DOCKETED	
Docket Number:	23-AFC-02
Project Title:	Elmore North Geothermal Project (ENGP)
TN #:	258994
Document Title:	Comments of the California Unions for Reliable Energy on the Preliminary Staff Assessment
Description:	Comments of the California Unions for Reliable Energy on the Preliminary Staff Assessment with Attachments A-H
Filer:	Alisha Pember
Organization:	California Unions for Reliable Energy
Submitter Role:	Intervenor
Submission Date:	9/4/2024 4:46:20 PM
Docketed Date:	9/4/2024

ELMORE NORTH GEOTHERMAL
PROJECT APPLICATION FOR
CERTIFICATION

COMMENTS OF THE CALIFORNIA UNIONS FOR RELIABLE ENERGY
ON THE PRELIMINARY STAFF ASSESSMENT

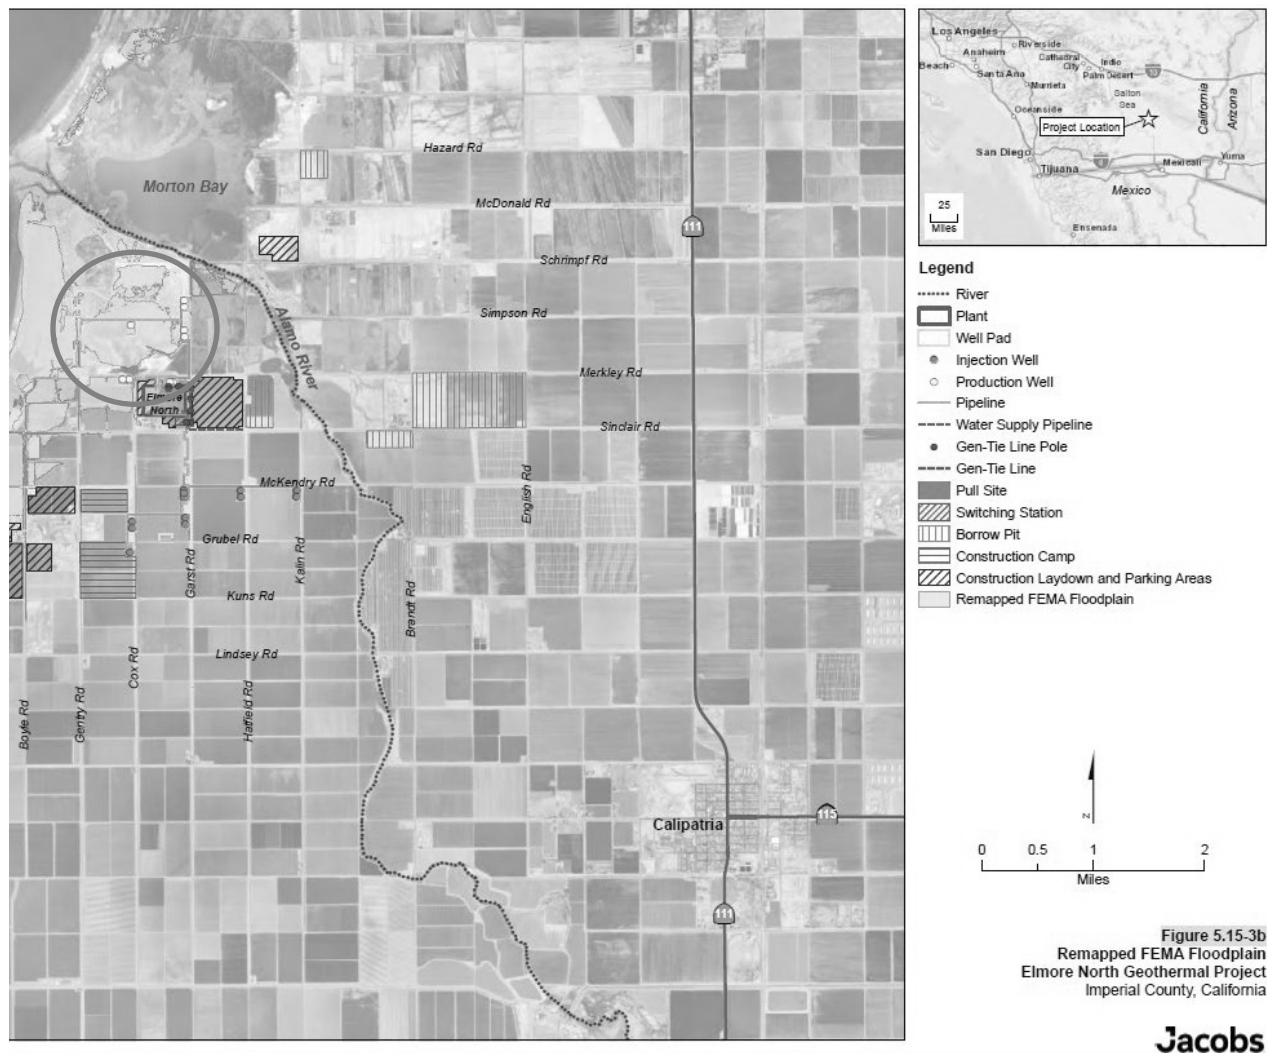
(“LOMR”) from the Federal Emergency Management Agency (“FEMA”) to remap the floodplain area.⁴⁶³ Several of the Project’s proposed production wells, well pads, and pipelines are currently within a FEMA Zone A, 100-year flood zone as generally indicated on the map below in the red circle.⁴⁶⁴ “Flood hazard areas identified on the [FEMA] Flood Insurance Rate Map are identified as a Special Flood Hazard Area (SFHA). SFHA are [labeled as “Zone A,” in relevant part, and] defined as the area that will be inundated by the flood event having a 1-percent chance of being equaled or exceeded in any given year.”⁴⁶⁵

These Project features will remain in the mapped FEMA 100-year floodplain even if the Applicant’s LOMR request is approved and this development would increase impervious surfaces in an area with high flood risks, thus exacerbating

Figure 1 : IID and Statewide (California) displacement factors for GHG Intensity

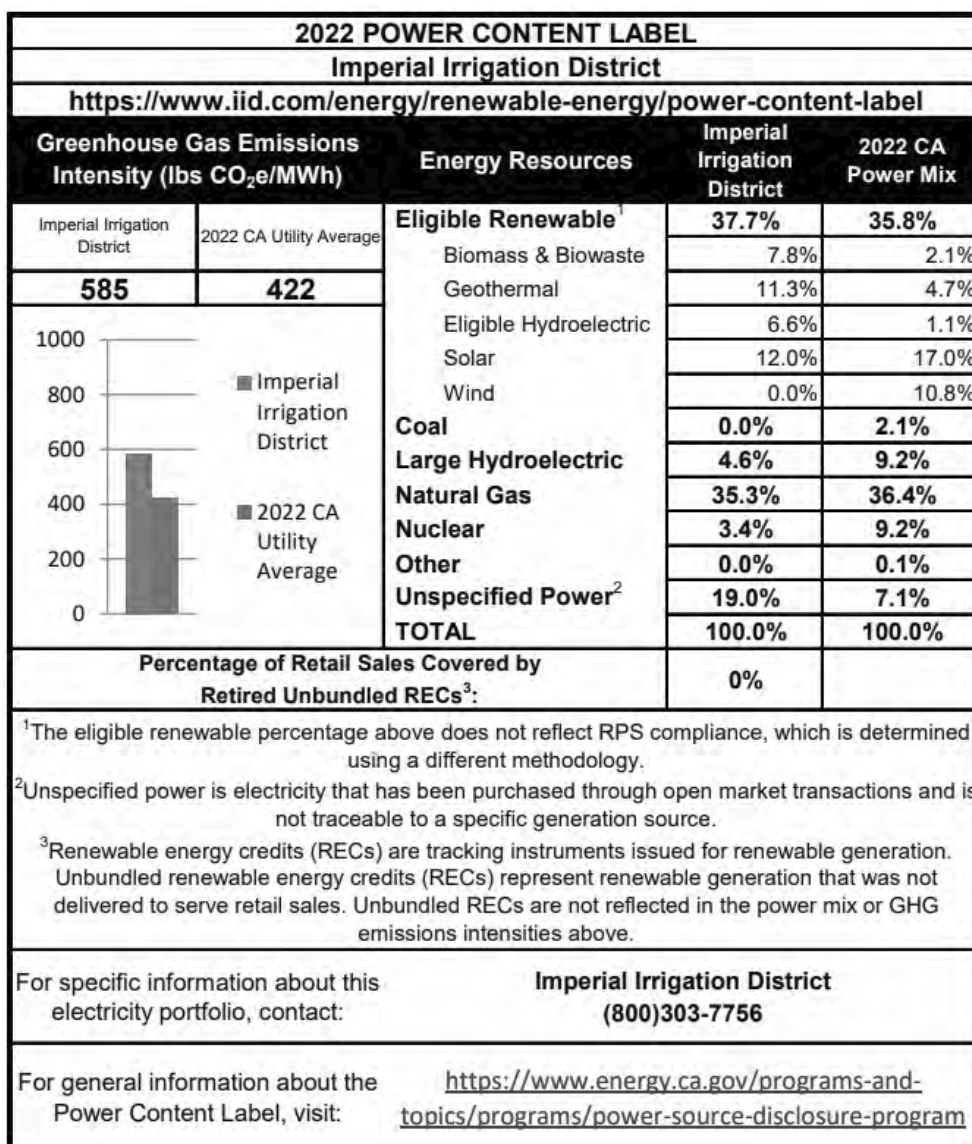
- Statewide Average (422 lbs CO₂e/MWh): Given that this is the average emissions intensity across California utilities, it captures a broader range of emission sources. The statewide average emissions intensity includes a mix of all generation sources in the state, including coal, less efficient natural gas plants, renewables, nuclear and other. This provides a more comprehensive picture of emissions associated with electricity generation. Moreover, the grid's energy mix can vary significantly

throughout the day and across different regions within the state, but the statewide average captures this variability and provides a more realistic estimate of the emissions associated with grid electricity.

Figure 2: Net emissions increase over project's lifetime (2025-2065)

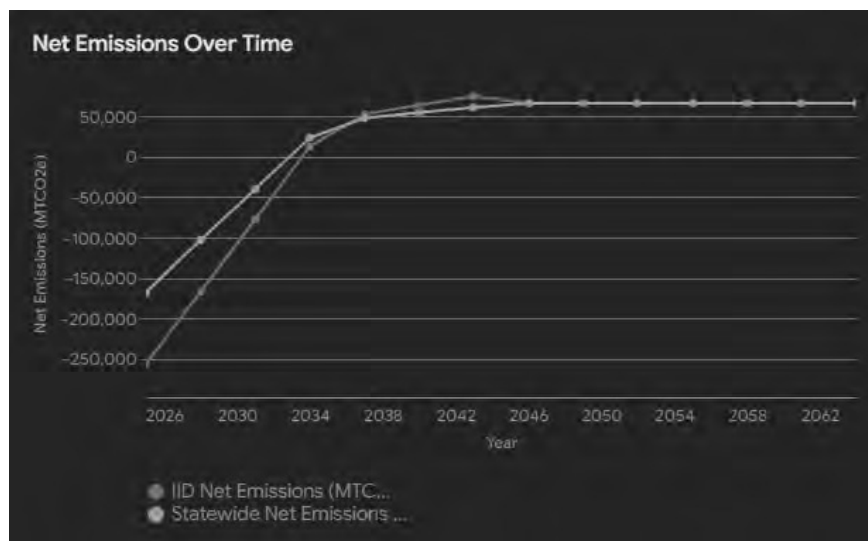
Both scenarios lead to a net *increase* in GHG emissions over the Project's lifetime (Table 1 and Table 2). Despite accounting for avoided emissions from displaced electricity generation, the Project's emissions—when assessed with the regional and statewide displacement factors—surpass the avoided emissions, undermining the intended environmental benefits. The Project's total carbon footprint remains positive. The plot (Figure 2) illustrates that the Project will contribute to rising net emissions over time, particularly after 2045. To ensure a precise evaluation and alignment with California's climate objectives, it is essential to use updated and dynamic displacement factors that accurately represent the real-time energy mix. The Project's claim of no net increase in GHG emissions is unsupported when considering the long-term transition to cleaner energy, emphasizing the need for a revised and comprehensive analysis that includes these critical elements. Given that the Project's GHG emissions would result in a net increase in GHG emissions, the PSA must identify mitigation measures to reduce the impact, such as those disclosed in the 2008 Technical Advisory⁴ issued by the Governor's Office of Planning and Research and the guidance from the California Air Pollution Control Officers Association⁵.

Figure 2: Wind Rose Plot Illustrating Wind Conditions at Sonny Bono Monitoring Station

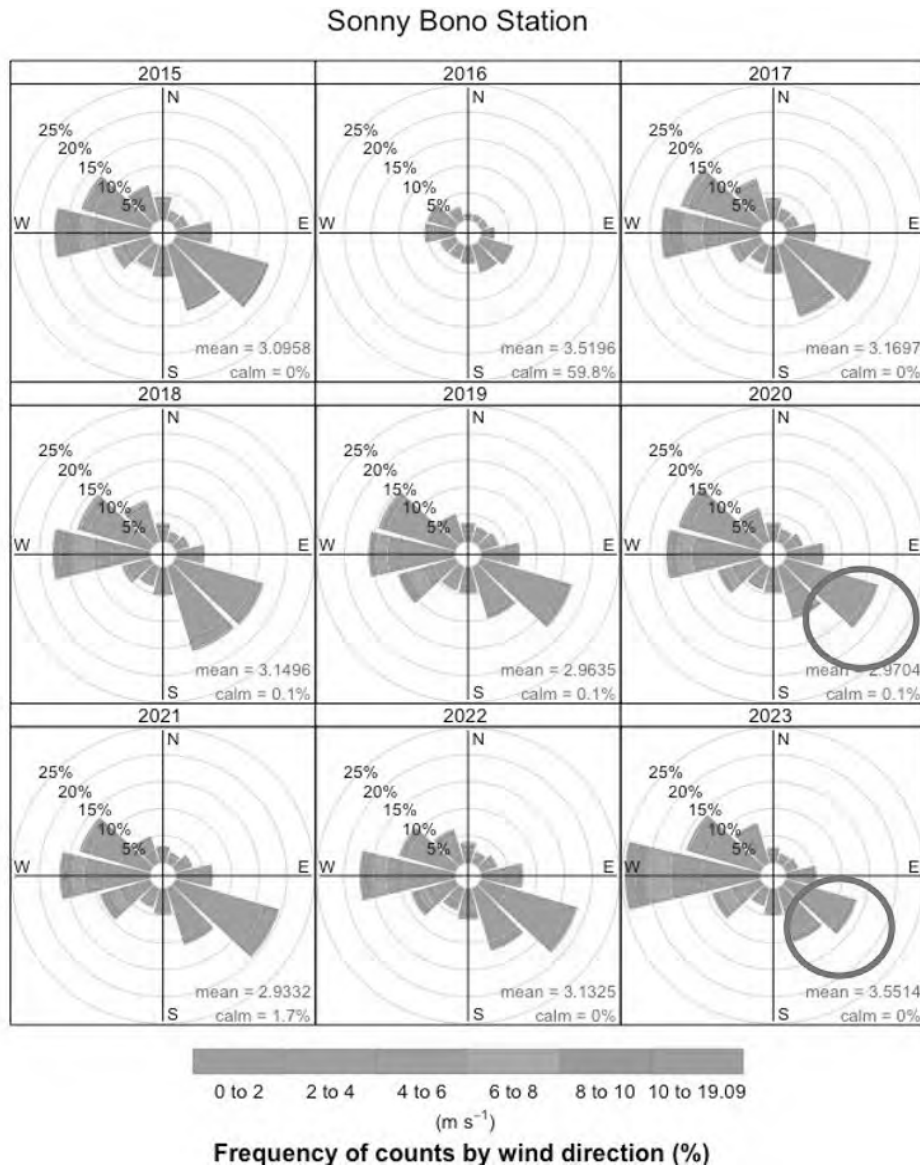
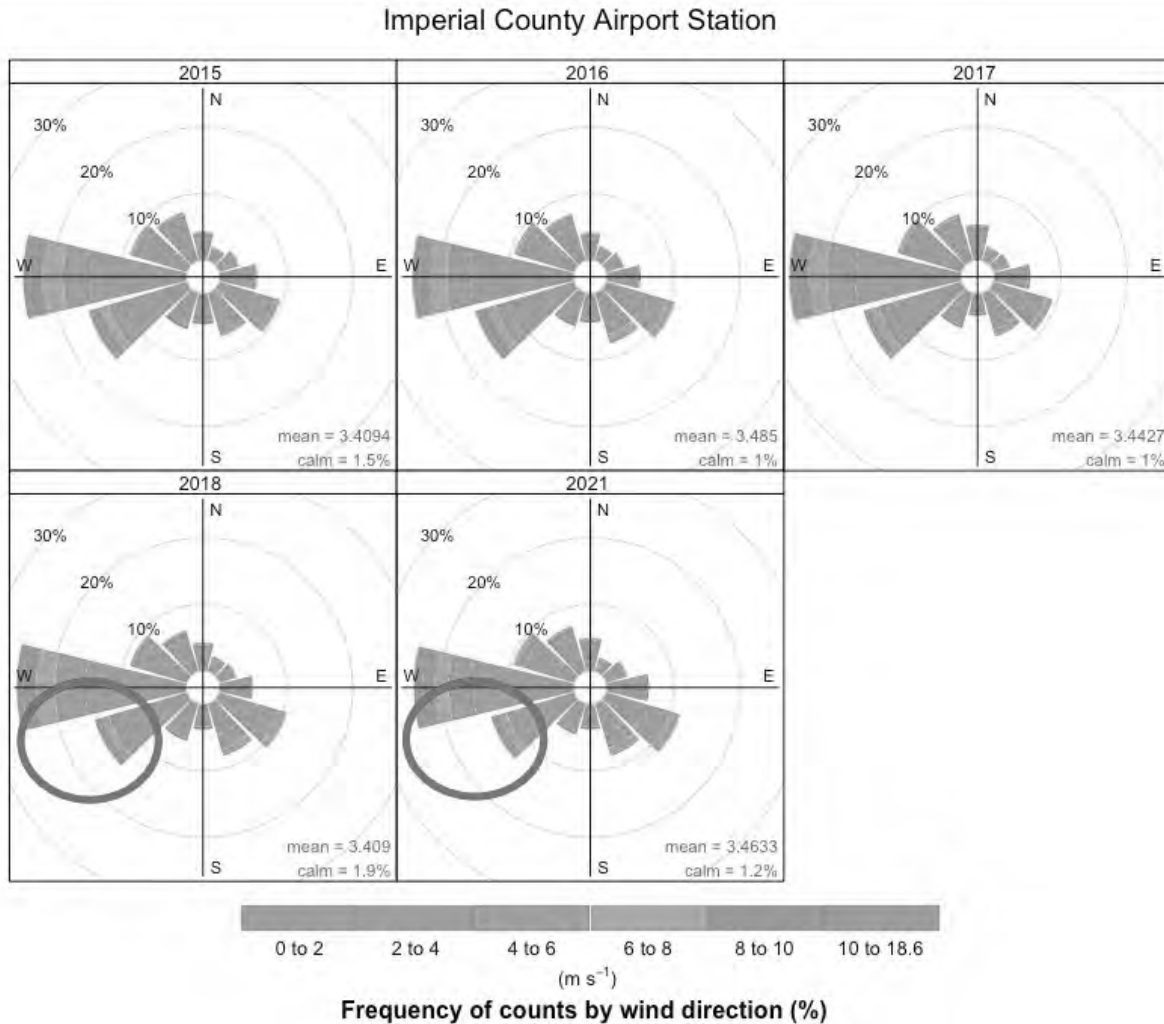
- ❖ **Comparative Analysis of Wind Roses:** The Applicant's comparison of wind roses from the Imperial County Airport and the Sonny Bono station is flawed. The Imperial County Airport data shows predominantly westerly and southwesterly winds (Figure 2), whereas the Sonny Bono station data shows predominantly southeasterly winds (Figure 3). This significant difference in wind direction further demonstrates that the Imperial County Airport data is not representative of the project site. Wind roses provide a general overview of wind patterns but do not capture the full spectrum of local atmospheric dynamics. Relying solely on wind rose comparisons ignores other important factors such as temperature, humidity, and atmospheric stability, which can significantly impact dispersion modeling.

Based on these points, the reliance on data from the Imperial County Airport, despite the lack of significant geographic features between the sites, does not provide the most accurate and representative meteorological input for the dispersion model. The closer proximity of the Sonny Bono station, coupled with its location near the shoreline and its ability to account for the internal boundary layer effect, offers a more relevant and precise data source that should be considered to ensure the integrity and accuracy of the air quality model.

Figure 6: Distance Between ENGP Plant and the Desert Valley Company Monofil Disposal Site

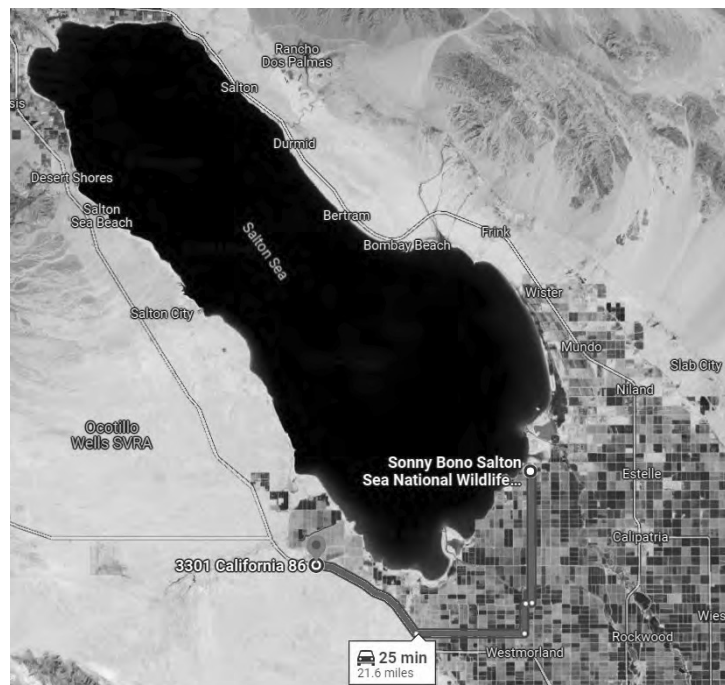
- ❖ **Long-Distance Transportation of Hazardous Filter Cake:** The PSA mentions that hazardous filter cake will be transported to a facility in Yuma AZ, which is approximately 129 miles from the project site (Figure 5). This distance significantly increases the vehicle miles traveled (VMT), leading to higher emissions of pollutants and GHGs.

To provide a realistic assessment, consider the emissions from heavy-duty trucks over this distance. Assuming a truck emits 1.161 grams of CO₂ per mile³⁶, the total emissions for a single trip (129 miles) would be 149.769 grams of CO₂. Given multiple trips, the cumulative emissions will be substantial.

Figure 4: Wind Rose For Imperial County Airport

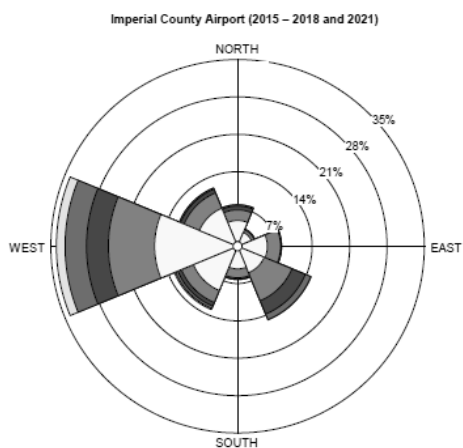
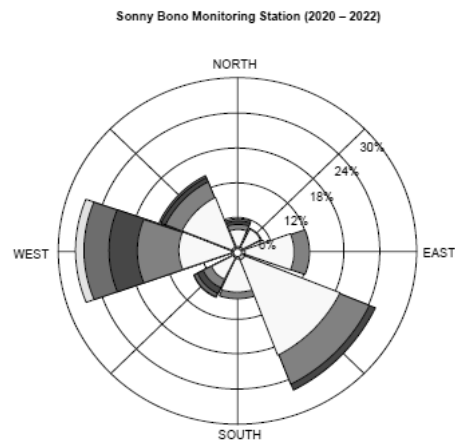
surrounding desert, leading to variations in wind speed. This can be seen when the wind data from the Imperial County Airport NWS station is compared to the Sono Bono Monitoring Station data.

Higher wind speeds over the heated desert and lower relative wind speeds over the cooler Salton Sea results in decreased dispersion near the Project site, increasing ground-level pollutant concentrations. Utilizing meteorological data from the Imperial County Airport NWS station fails to capture these localized effects. As a result, the Staff Assessment severely underestimates the Project’s air quality and public health risk impacts.

Figure 2: Valley Fever Incidence And Soil Disturbance

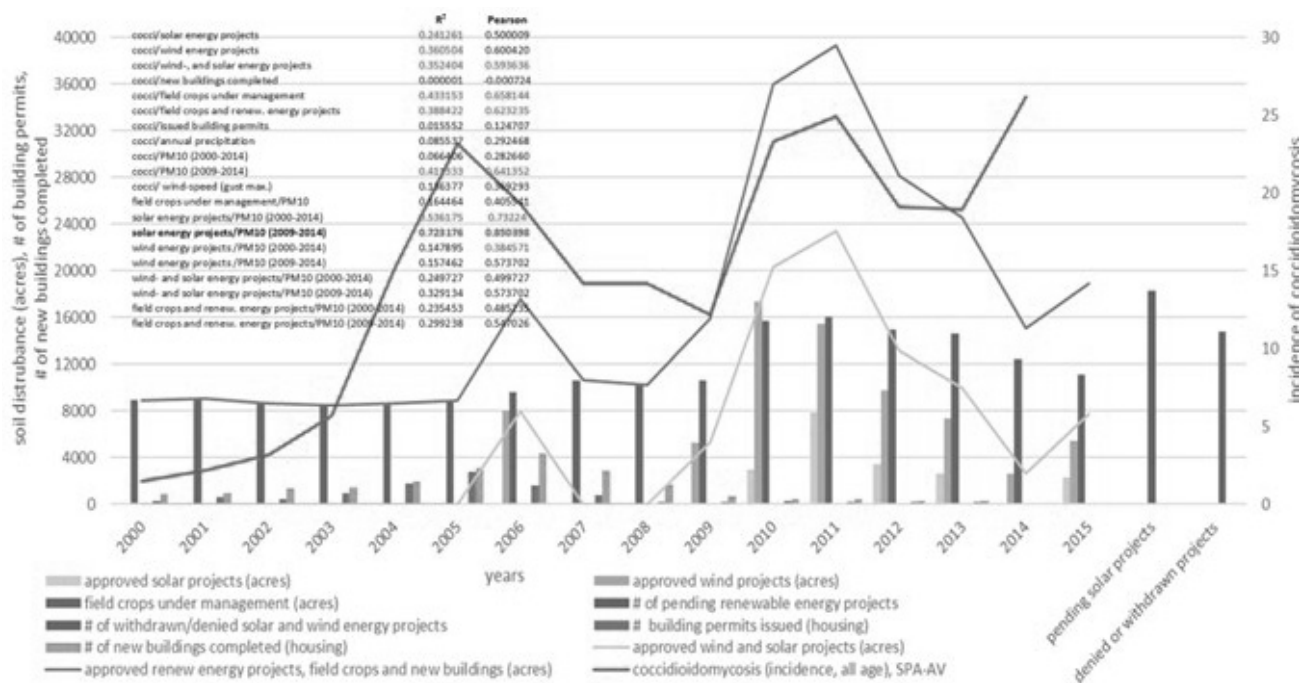
As shown in the study, the incidence rate of Valley Fever increased with the number of acres of disturbed soil. The mass disturbance of soils during Project construction will create similar conditions to those detailed in the study by Colson.¹²

Figure 1. Site map showing location of plant and production wells circled in blue (reproduced from ENGP PSA Figure 3.3)

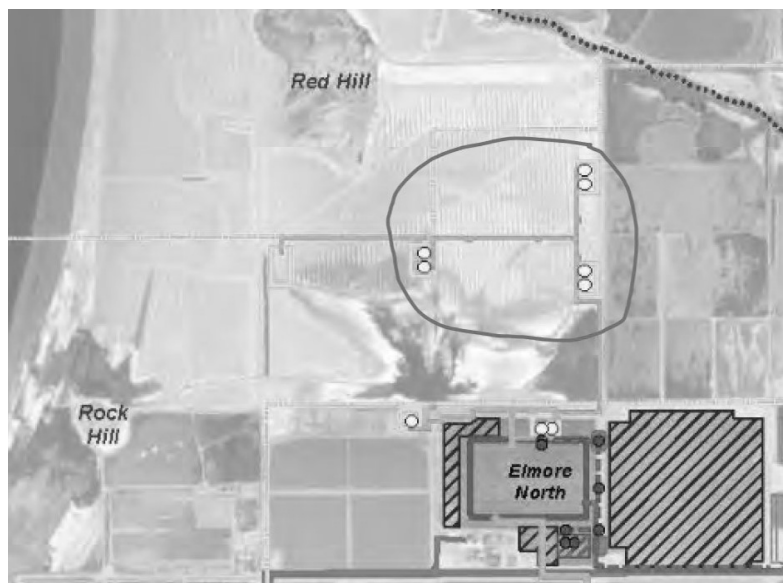
Six production wells and the associated well pads are outside the plant site to the north of the project site (see Figure 3-3 of PSA reproduced in part below as Figure 1) and would be located in areas dominated by poorly drained soils with high flood risk. The flood risk is high because of (1) shallow groundwater, which means the surface water has nowhere to go if it infiltrates, and (2) clayey soils with low infiltration rates, meaning surface water cannot infiltrate fast enough before ponding (and flooding) happens at the surface. The construction of new, additional impervious surfaces (e.g., Project well pads) in areas of high flood risk would increase the impacts from flooding. Additionally, these Project features will also be located outside the berm intended to protect the plant area so there is no mitigation proposed for significant impacts from flooding in these areas. Engineering controls are necessary to mitigate flood risk, yet the PSA fails to adequately analyze and mitigate these impacts.

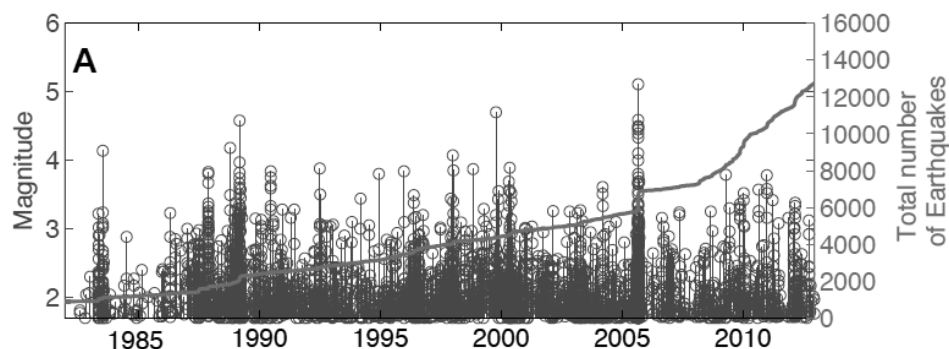
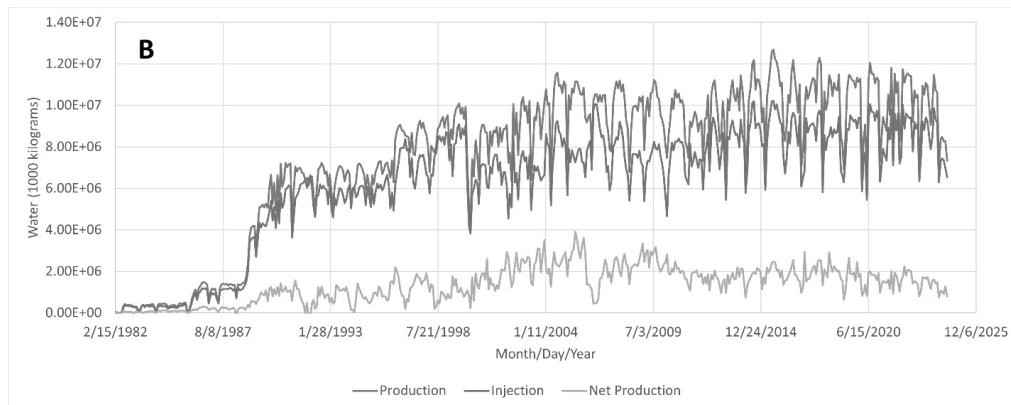
Water production and injection data, shown in Figure 4, show an increase in geothermal operations after 1986, with amounts of produced and injected water more than doubling from lows of less than 2 billion kilograms (kg) during the pre-1986 period to averaging 10 billion kg of produced water and 8 billion kg of injected water. Seismicity and water production/injection data show that some correlation exists between the

increased geothermal activity (Figure 4) in the project area and the increased rate of seismicity (Figure 3). Using these data from the Salton Sea Geothermal Field (SSGF), Brodsky and Lajoie (2013) concluded that net production volume combined with injection information is a good predictor of the seismic response in the short term for a fully developed field. The data, according to Brodsky and Lajoie (2013), suggest that the increase in geothermal activity in the study area is correlated with a corresponding increase in the seismicity rate.
